SUBJECT: AMENDMENT DEFICIENCY MAIL CONTROL NUMBER 610951

In your letter dated December 17, 2018, you requested to remove the "Anderson Building" location from your NRC license. In order to continue our review, additional information is needed.

Subject: Amendment Deficiency Mail Control Number 610951

Photo showing locations of sink wipe tests.

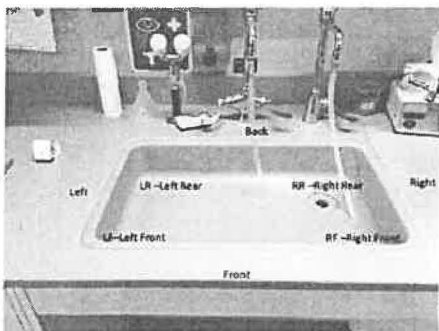
2. Please perform wipe tests of the sink traps where the material was disposed and submit the results to the NRC for review.

Wipe tests of the sink and P-trap were taken. The P-trap could not be disassembled and wiped as the pipe fittings are glued together. The wipes were taken from the entire surface of the plug and from the inside of the P-trap pipe to the best of our ability.

Wipes were counted on a Beckman LS 6500 liquid scintillation counter for 5 minutes using a wide window, and the efficiency of counting was estimated to be 35% (estimate provided in Beckman literature). The wipe test results are shown in the following table.

The results show that the removable surface contamination does not exceed the limit of 4,500,000 dpm per 100 cm² for iron-55 as specified in NUREG 1757, Appendix B, Table B.1.
